Type 570

PRODUCT	MODIFICATION	INDEX
---------	--------------	-------

product modification

WAVESHAPE IMPROVED

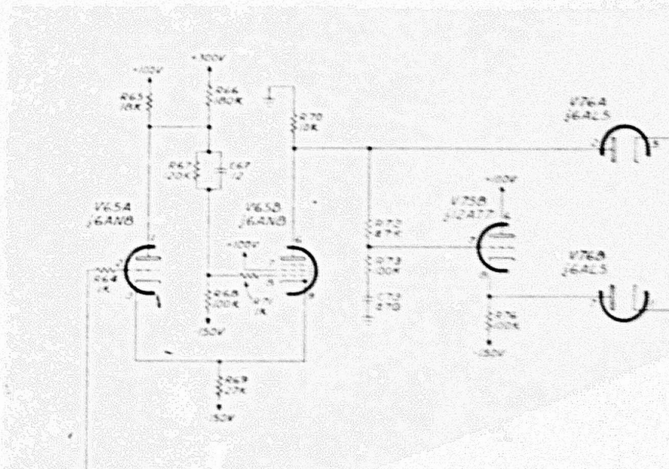
To insure that the first step of the Step Generator is flat, the following changes were made: 1) The plate resistor of V65B was changed from 4.7K to 10K. 2) R75, the 1K resistor that connected the plate (pin 6) of V65B to the grid (pin 7) of V75B was replaced with a divider network.

C73	281-0525-00	Capacitor, Cer	470pF	500V	
R70	302-0103-00	Resistor, Comp	10k	1/2W	10%
R72	302-0473-00	Resistor, Comp	47k	1/2W	10%
R73	302-0104-00	Resistor, Comp	100k	1/2W	10%

POWER TEST ON SWITCH REWIRED

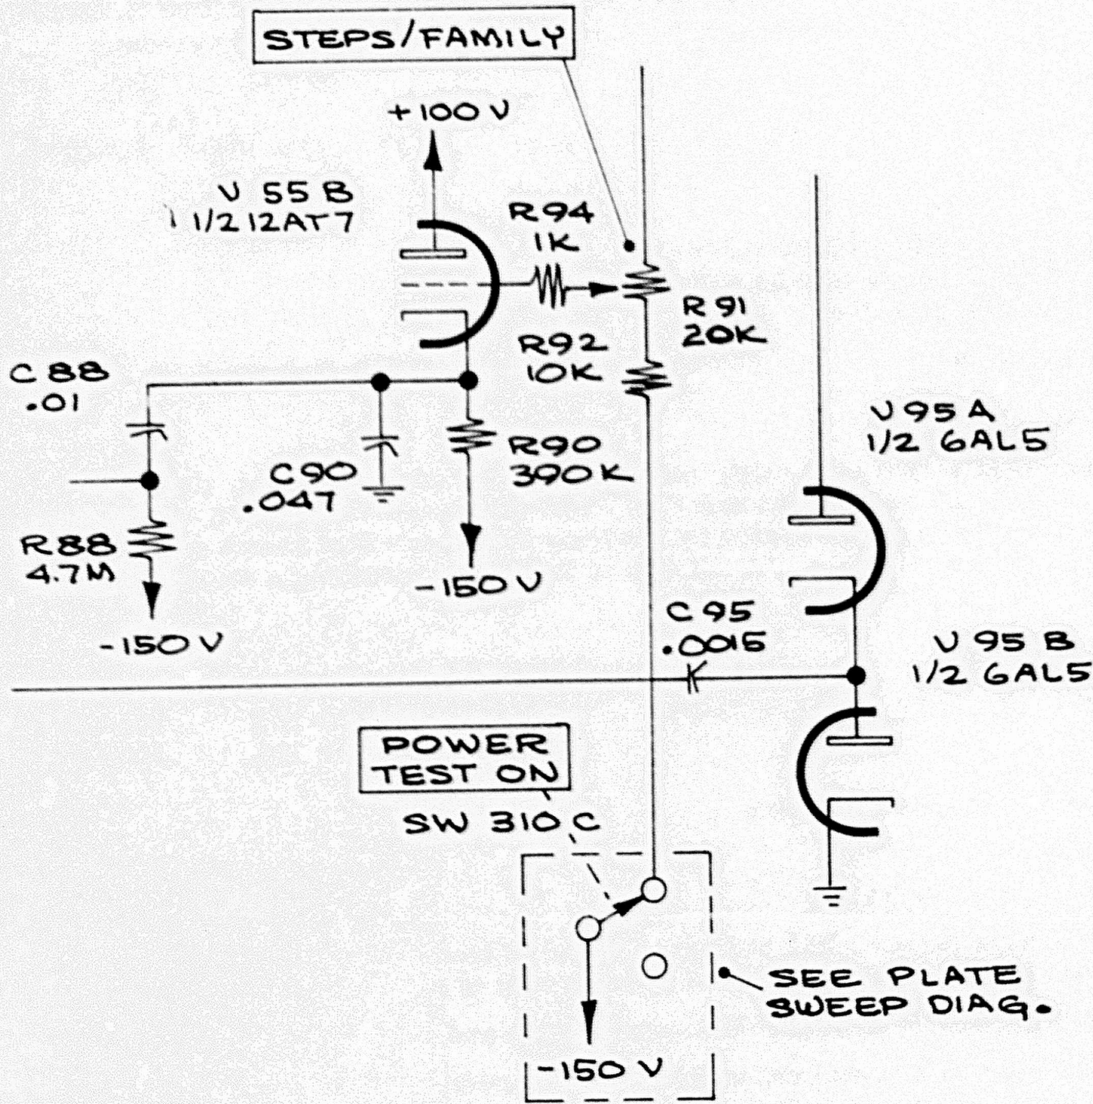
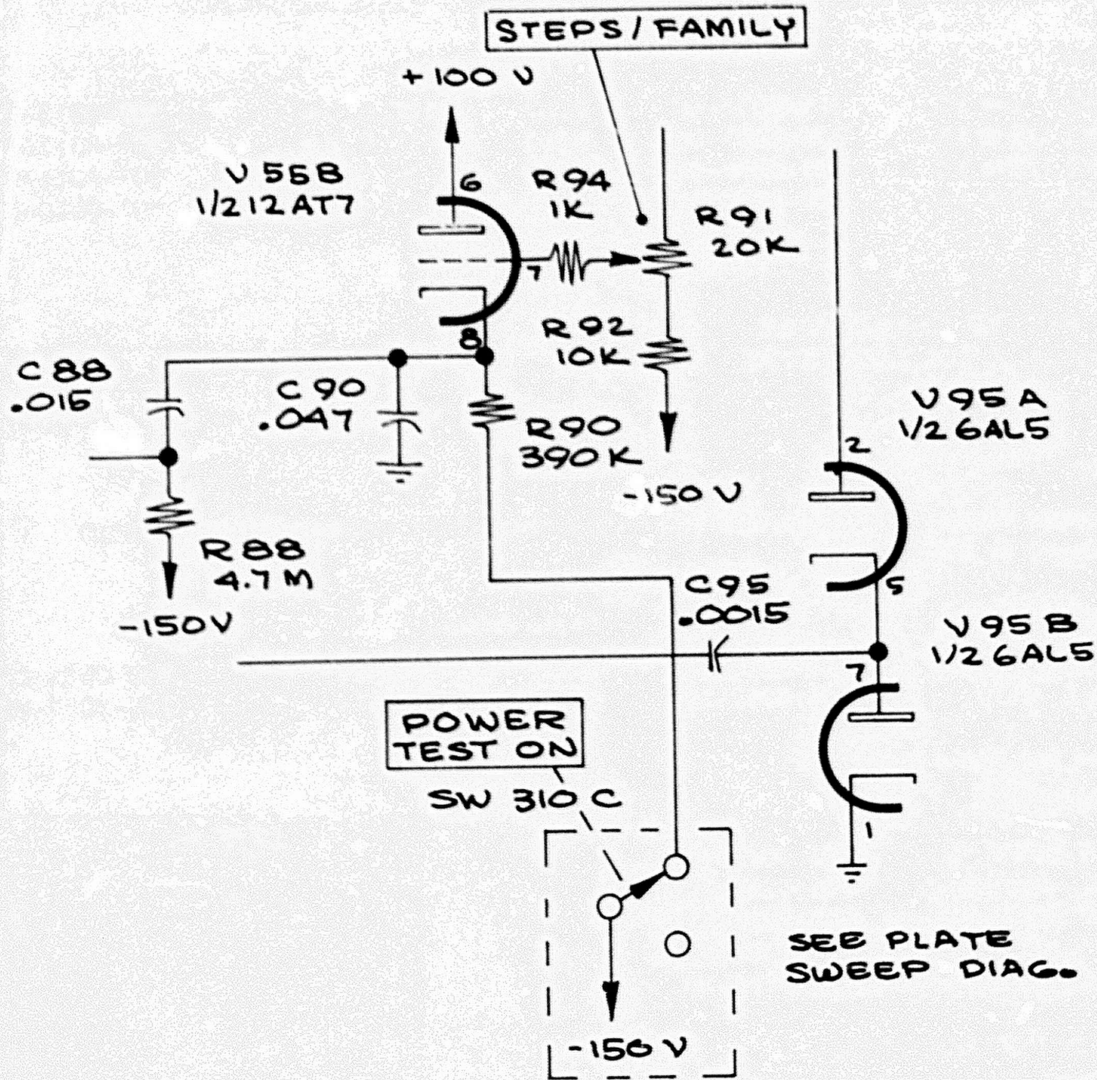
With the POWER TEST ON Switch in the OFF position, V86, the step generator, draws 10 to 15 ma's screen current placing V86 and V470, the +100V series regulator, out of dissipation. This condition was eliminated by rewiring the POWER TEST ON Switch from the grid of V55B, the Step-Control CF, to the cathode of V55B, and installing a divider for the grid of V55B.

- a) Locate the blue wire connected between R92 and the top terminal of the TEST POWER ON Switch SW310C. Move switch end of wire to -150V terminal at other side of switch.
- b) Locate R90 in cathode of V55B. Disconnect the bare wire and two -150V leads at inner end.
- c) Run a grey-white wire from end of R90 (just cleared) to a blank notch on strip just behind meter. Run grey-white wire from notch just used through chassis to the TEST POWER ON Switch SE310C. Connect to terminal from which blue wire was removed.
- d) Locate other end of -150V strap. Remove strap and connect two -150V leads previously disconnected.
- e) Replace R69 (27k 1/2W 10% resistor) with a 27k 1W 10% resistor.
- f) Install R474 (150k 2W 10% resistor) from pin 1 to pin 3 of V470A.

BEFORE
MOD 1809

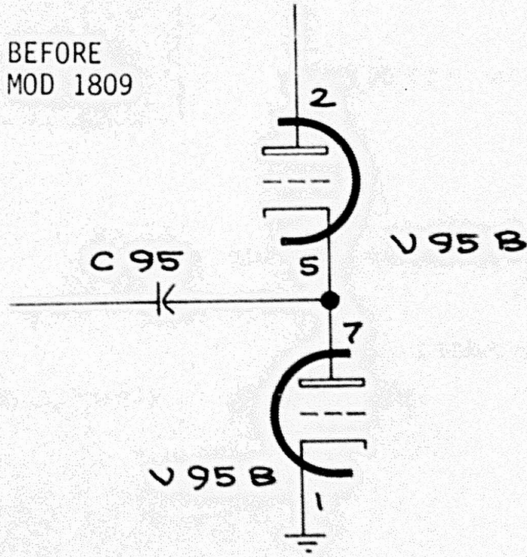
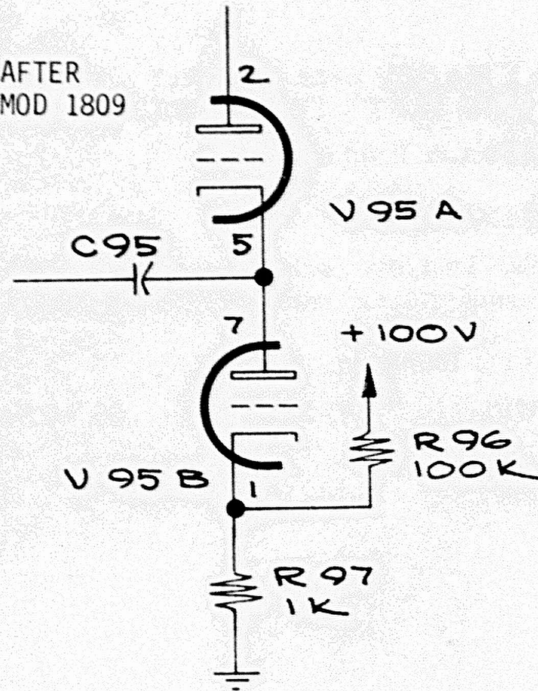
An apparent change in step amplifier sensitivity occurs when switching the BASE-STEP GENERATOR Switch from 120 to 240 STEPS/SEC. This appears as a change in amplitude of the step generator waveform.

A small 'low contact resistance' current flow through diode V95 during its non-conducting period, especially with unaged diodes, causes a slight drop in plate voltage of the Miller tube, V86, between steps.

Current flow through V95 during the non-stepping period of the stairstep waveform is prevented by biasing the cathode of the diode approximately 1 volt positive with respect to the plate.

- a) Install R97 (1k, 1/2W 10% resistor) from cathode V95B to ground
- b) Install R96 (100k 1/2W 10% resistor) from cathode V95B to +100V supply.

Old Wiring

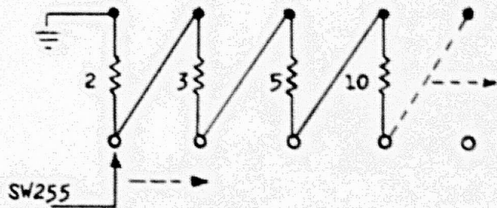
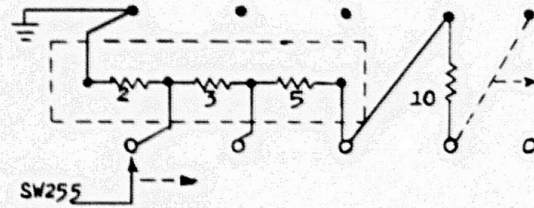
Mica plate resistor 310-546 replaces the three low wattage 1% resistors, 307-010/011/012, on the VERTICAL MA/DIV switch. Since the 310-546 is a precision multi-tapped resistor, all three resistors must be replaced whenever one of them is to be replaced.

Higher wattage resistors are needed to handle short circuit conditions on the switch.

1. Remove the following from the SW255, VERTICAL MA/DIV switch:
 - () R265, a 2Ω 0.12w 1% precision resistor
 - () R264, a 3Ω 0.18w 1% precision resistor
 - () R263, a 5Ω 0.30w 1% precision resistor
- () 2. Install the mica plate resistor, from the kit, using the drawing as a wiring guide.

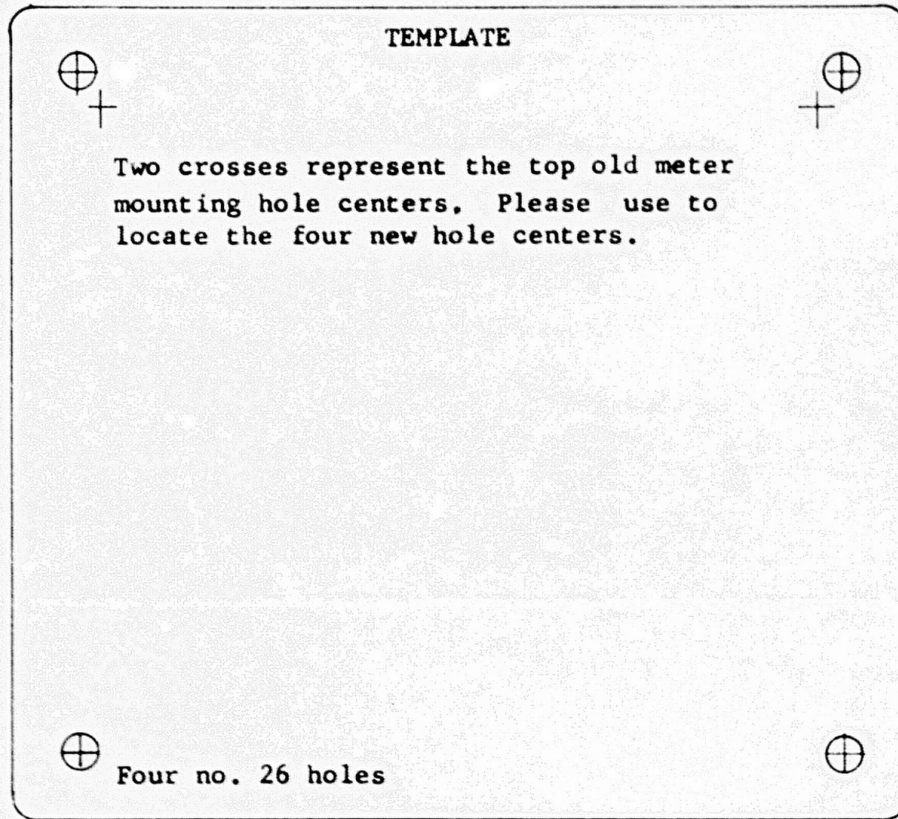
- () 11. Using the template on page 4, mark and drill four new mounting holes in the instrument panel with a no.26 drill, to accommodate the mounting studs of the new meter.
- () 12. Install the new meter (from kit) in the instrument.

M1912

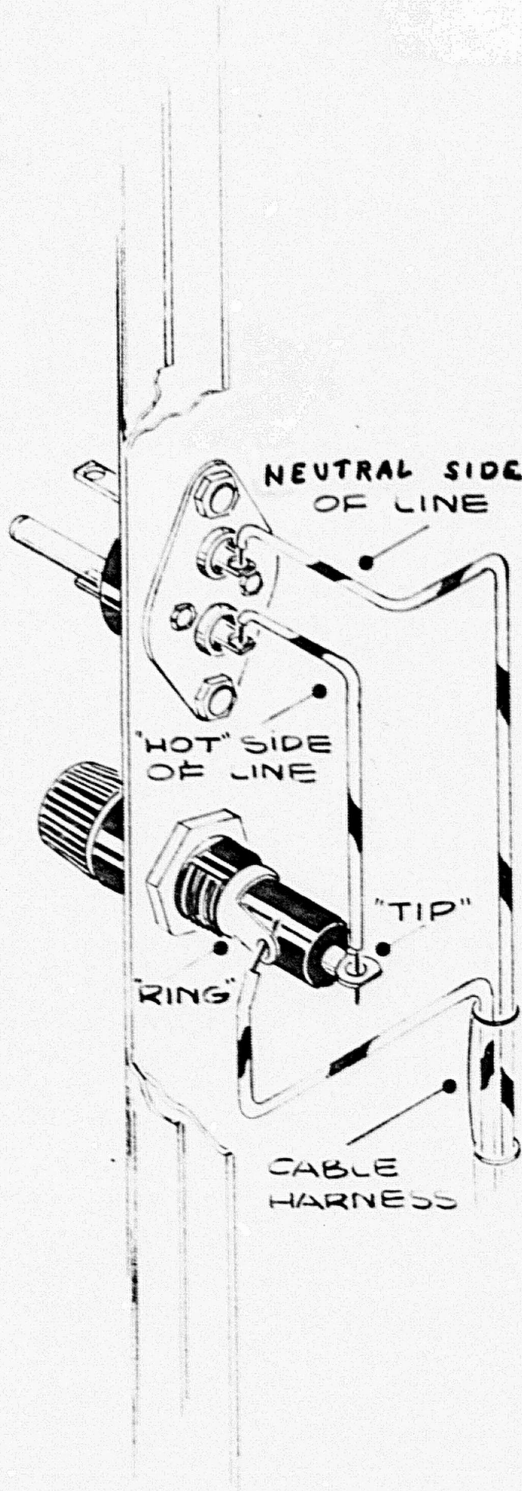
The 2-wire motor base connector presented the possibility of connecting the "HOT" side of the AC power line to either side of the Power transformer, depending upon how the power cord was inserted. This problem was eliminated by changing the 2-wire connector to a 3-wire connector. The power line cord can only be inserted one way in the 3-wire connector, because of the added ground post. Also see Mod 2015 and Mod 7521.

- c) Turn POWER Switch off.
- d) Using an Ohmmeter, determine which wire is connected to the POWER Switch. Solder this wire to the fuse holder "RING" connection. See drawing.
- e) Solder the short wire between the fuse holder "TIP" connection and the "HOT" side of the 3-wire connector. See drawing.
- f) Solder the remaining cable wire to the neutral side of the 3-wire connector. See drawing.

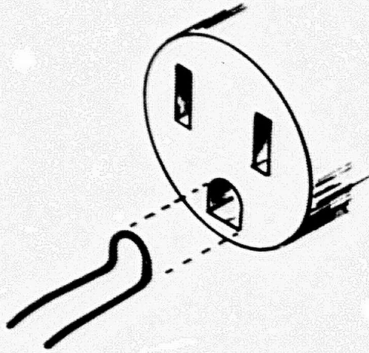
Modification Kit, PN 040-0424-01, improves the non-current carrying ground contact on the 3-wire power cords, used on TEKTRONIX Type instruments, by adding a spring to the female contact.

- () Insert the spring (from kit) as indicated in the drawing below, and push it in by plugging the male end of the power cord into the female end.
